PD Modification Application: PRS 25-0921

BOCC Land Use Meeting Date: August 12, 2025

AGENCY REVIEW COMMENT SHEET

PETITION NO: PRS 25-0921

2.4 Proposed Site Plan (partial provided below for size and orientation purposes. See Section 8.2 for full site plan)

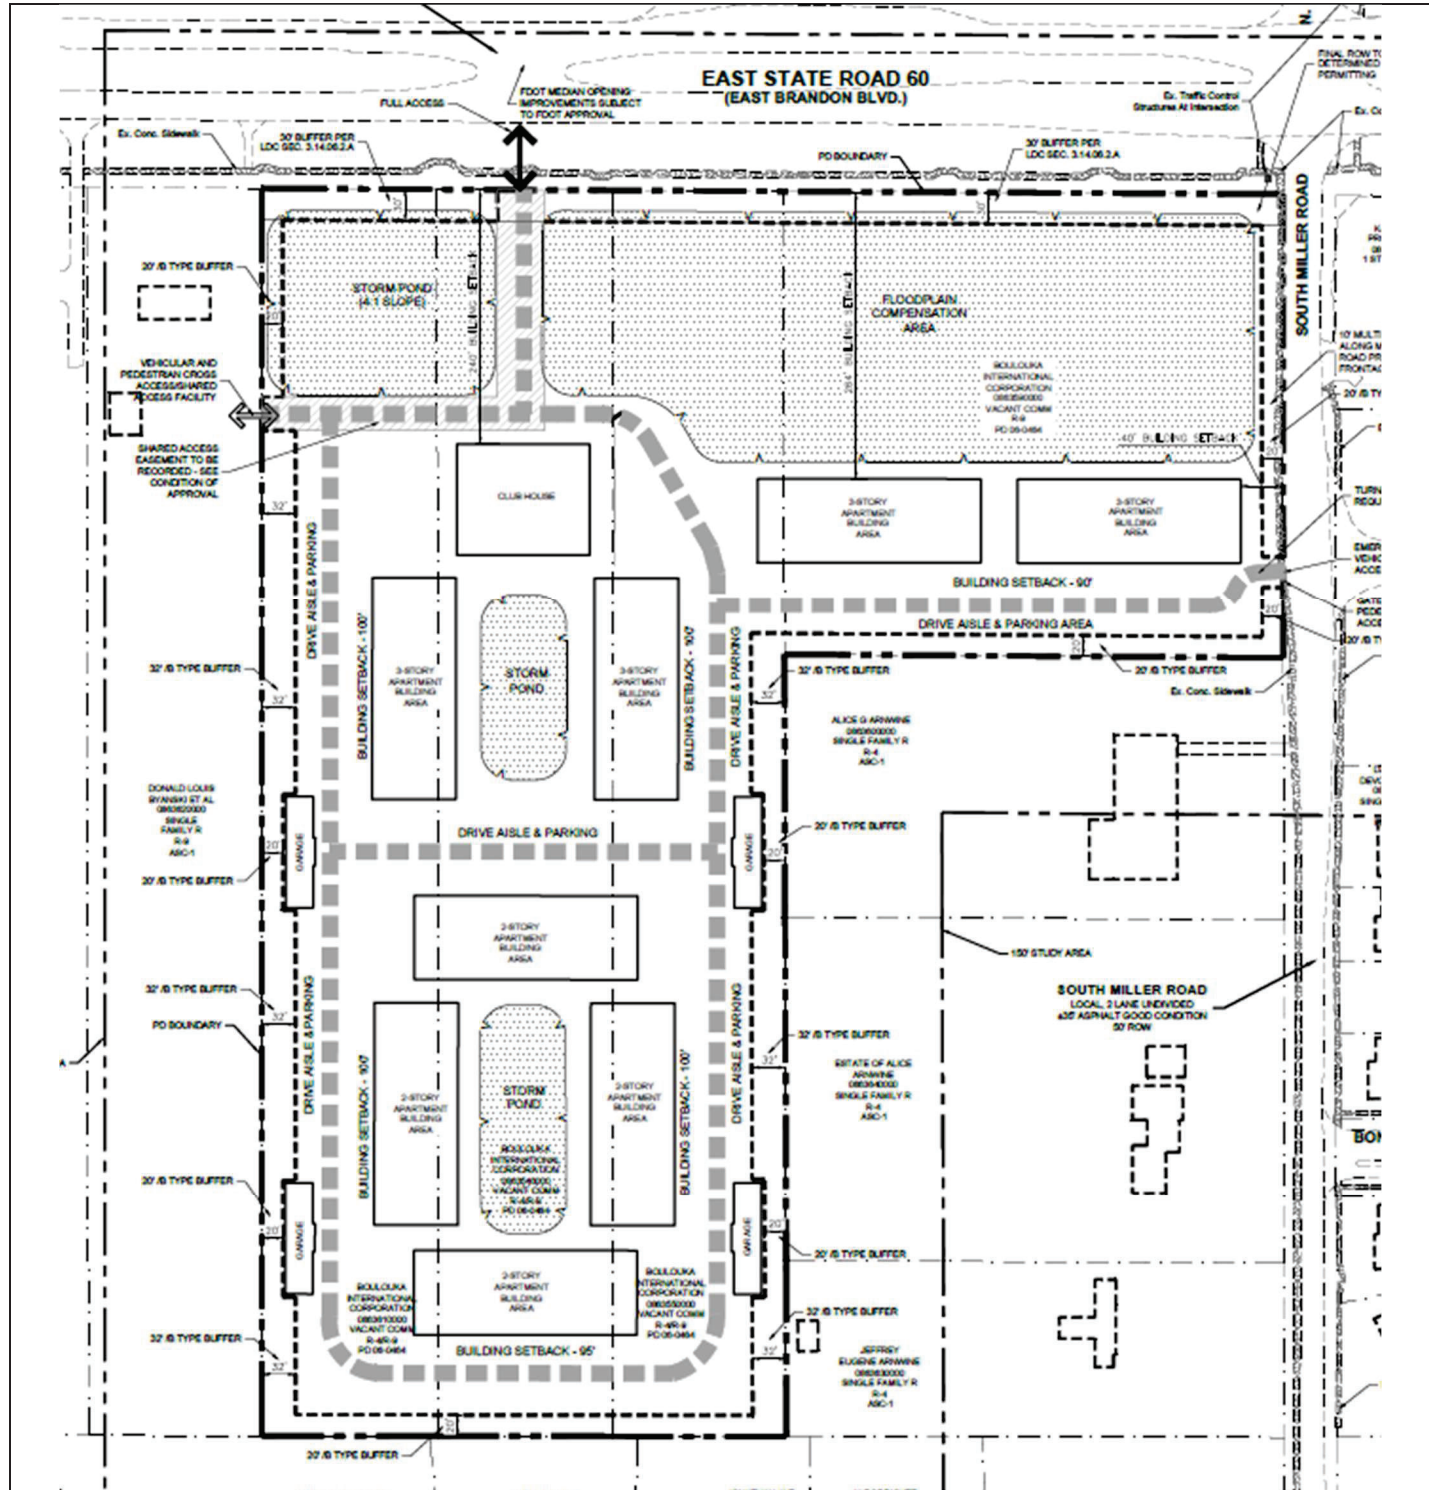
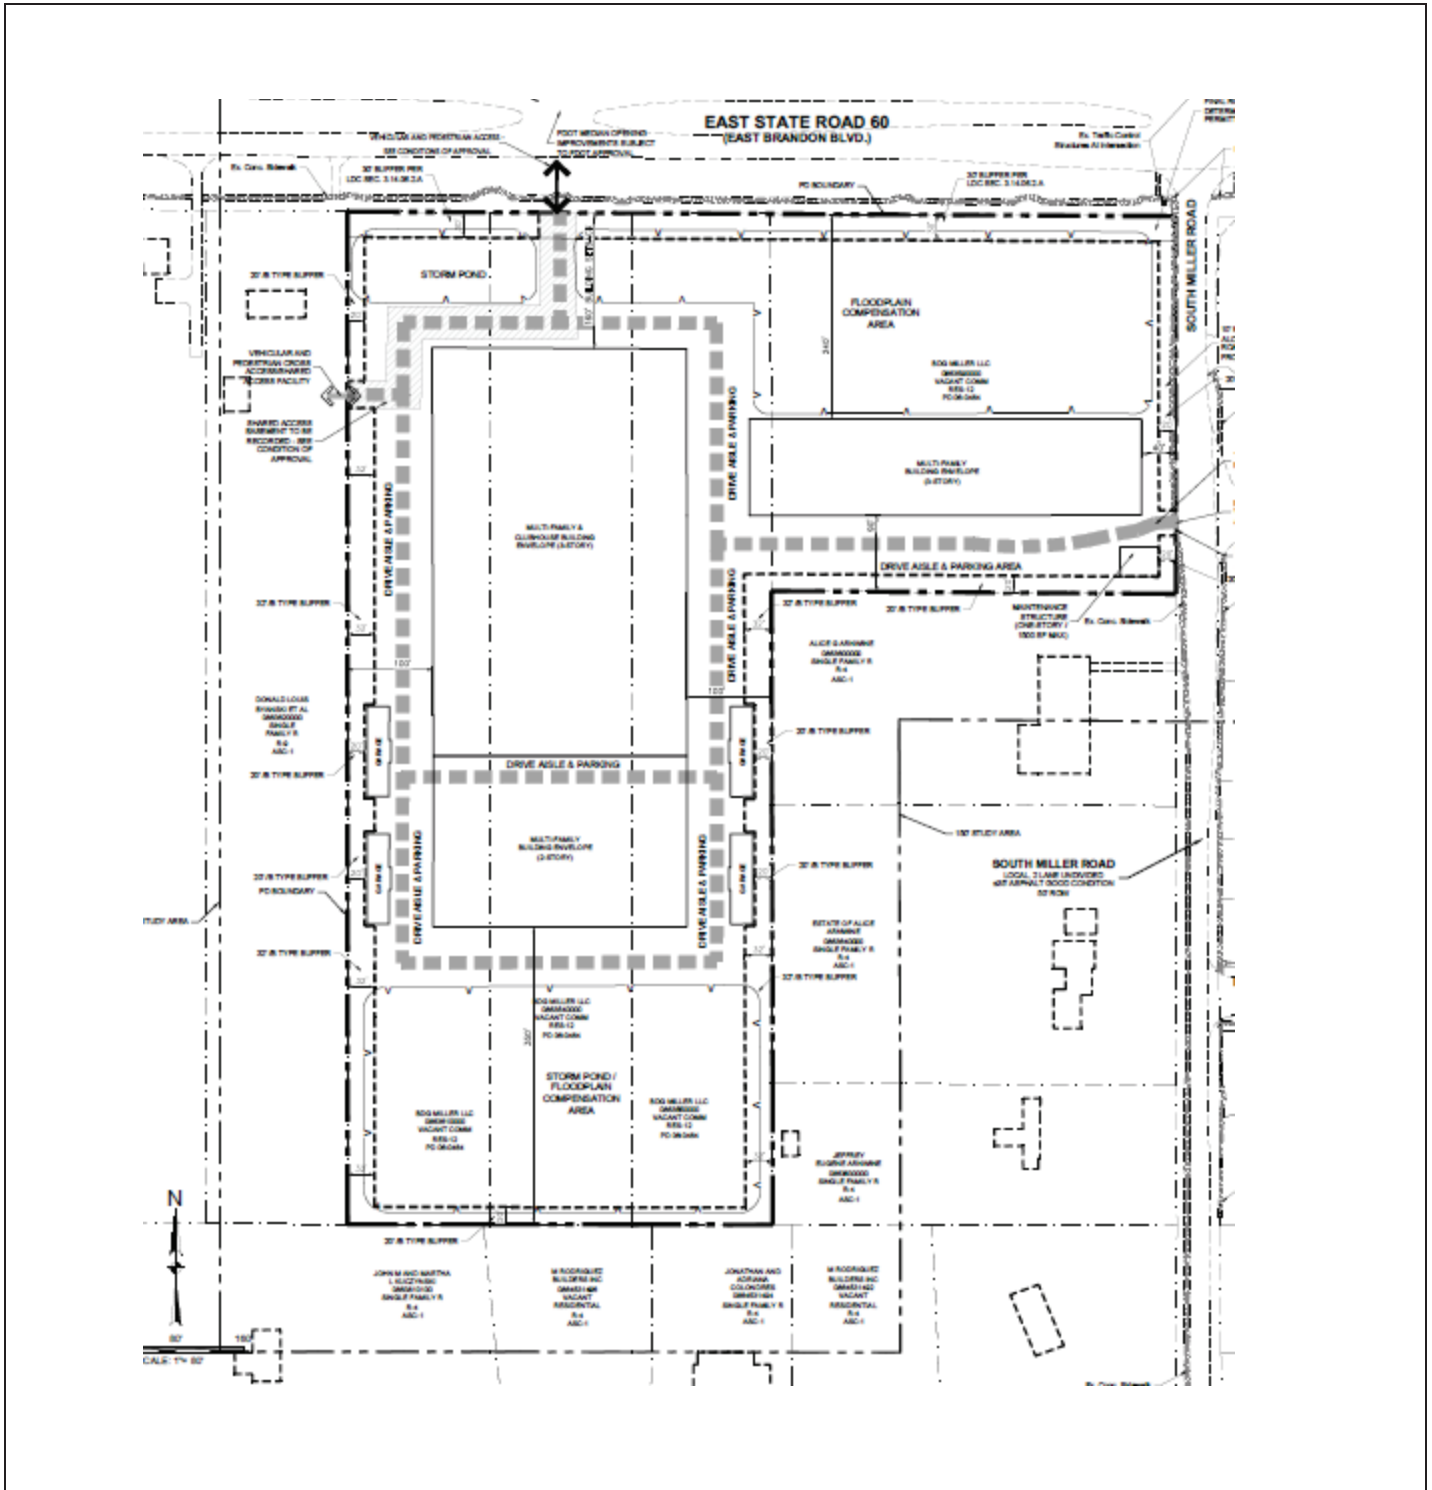
The proposed modification seeks to move development northward, toward State Road 60, providing a larger setback to the south. Residential uses are found the immediate south. The building envelopes will provide greater flexibility for individual building layouts; however, no change to building height, side setbacks, or buffering and screening is proposed. No access changes are proposed.

PROPOSED PRS

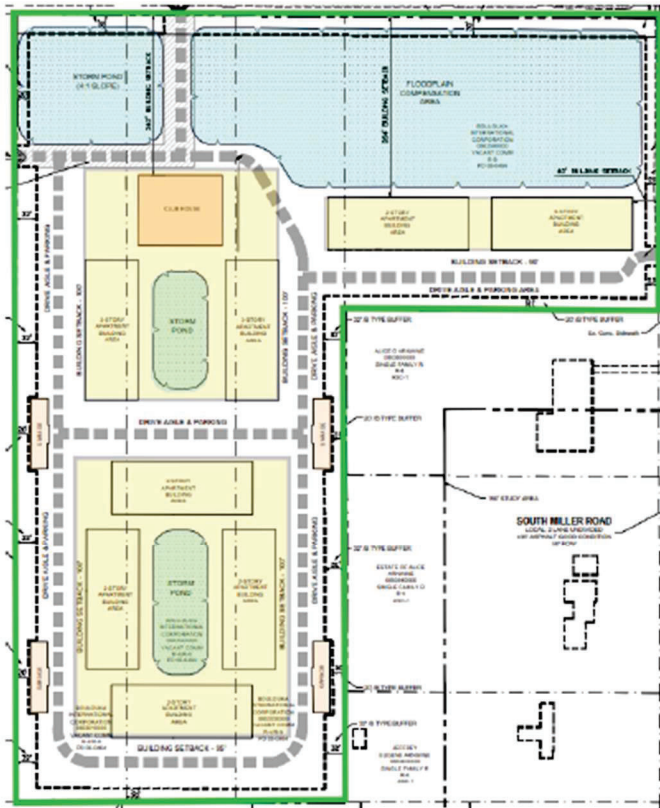
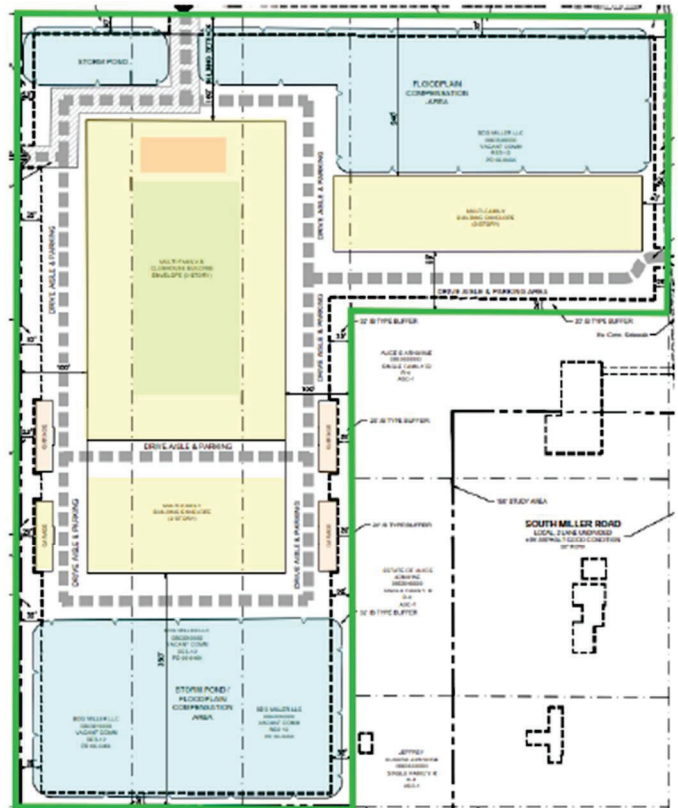
- Prior to certification, the applicant revise the PD site plan as follows:
 - a. Revise the label “Full Access” to “Vehicular and Pedestrian Access – See Conditions of Approval”

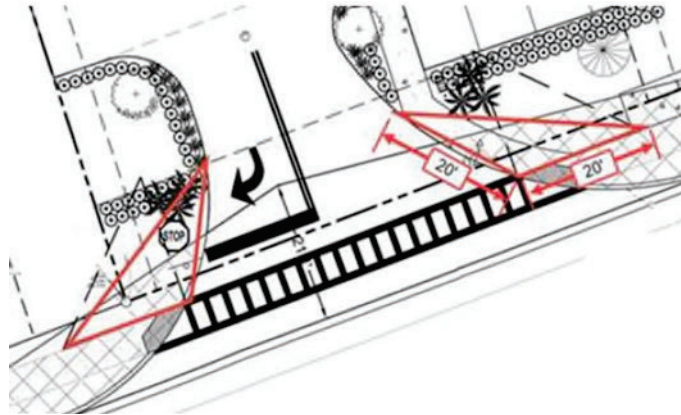
8. Maintain 20' x 20' pedestrian sight triangles and draw the triangles on the plans to show there are no obstructions taller than 24" within the triangles. Also, no parking spaces can be in these triangles Measure 20' up the sidewalk and 20' up the driveway from the point at which the sidewalk meets the driveway. Here is an example of what these triangles look like and how they are positioned.
